Access Compliance Report

Public Rights-of-Way (Curb Ramps)

Intersection ID: 45776	Main Street: CRABAPPLE_TREE_LN	Cross Street: CARVER_FALLS_RD	Location:	N
ADA ID: 3C105B42291E	Ramp Type: PerpDiag	Initial Pass/Fail: Fail	Overall Compliance: No	Severity Score: 13.75
Codes/Mitigation Info/Possible Solution		Field Measurements/Component Compliance

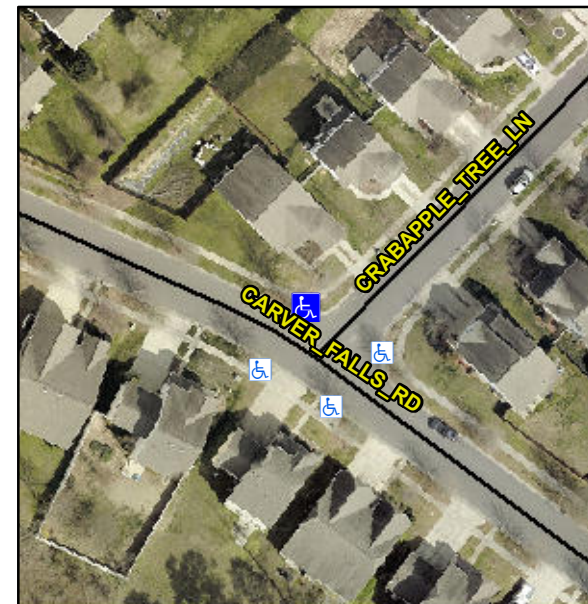
R304.2.2, R304.5.3

Compliance	Description	Data	Compliance	Description	Data
N/A	Ramp Length (in)	71.0	No	Ramp Slope (%)	8.7
Yes	Ramp Width (in)	48.0	No	Ramp XSlope (%)	2.3
N/A	Flare Type LT	N/A	N/A	Flare Type RT	N/A
N/A	Flare Slope LT (%)	N/A	N/A	Flare Slope RT (%)	N/A
N/A	Flare Traversable LT?	N/A	N/A	Flare Traversable RT?	N/A
N/A	Landing Length (in)	N/A	N/A	DWS Provided?	N/A
N/A	Landing Width (in)	N/A	N/A	DWS Contrast?	N/A
N/A	Landing Slope (%)	N/A	N/A	DWS Length (in)	N/A
N/A	Landing X Slope (%)	N/A	N/A	DWS Full Width?	N/A
N/A	Landing Curb? (Y/N)	N/A	N/A	DWS Offset (in)	N/A
N/A	Shared Landing?	N/A			
N/A	Gutter Ponding?	N/A	N/A	Gutter Slope (%)	N/A
N/A	Gutter Lip Ht (in)	N/A	N/A	Gutter X Slope (%)	N/A
N/A	Painted X Walk1?	No	N/A	Painted X Walk2?	No
	X Walk 1 Direction	To SW		X Walk 2 Direction	To SE
N/A	X Walk 1 Width (in)	N/A	N/A	X Walk 2 Width (in)	N/A
	X Walk 1 Slope (%)	1.5		X Walk 2 Slope (%)	0.2
	X Walk 1 X Slope (%)	0.7		X Walk 2 X Slope (%)	1.8

Remove & Replace Curb Ramp With Two New Directional Ramps or Equivalent.
